RIDE THE DUCKS INTERNATIONAL

Bulletin No. SB-00-07-13

SERVICE BULLETIN

Emergency Curtain Release System

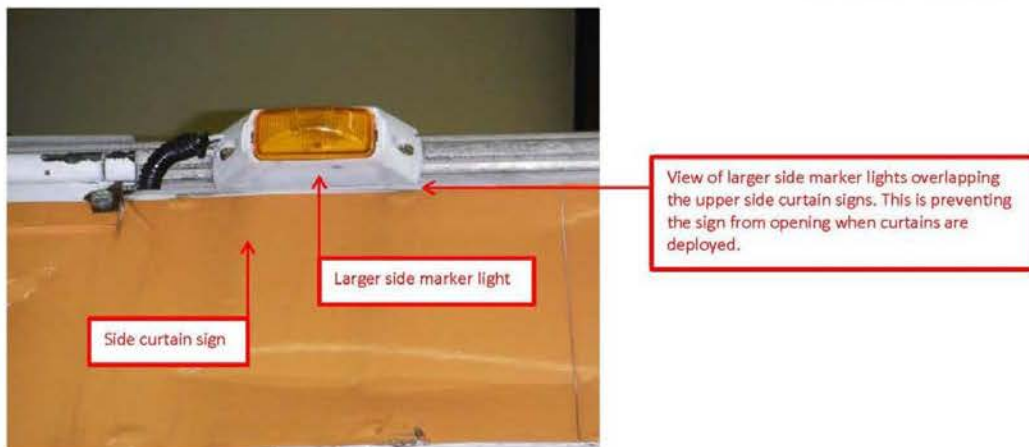
Holes showing where the hinges were previously located.

Curtain release hinges had to be moved back down to the original location.

With the vertical curtain guides and hinges located in the upper position, the vertical curtain guides hit the upper sign preventing them from opening.
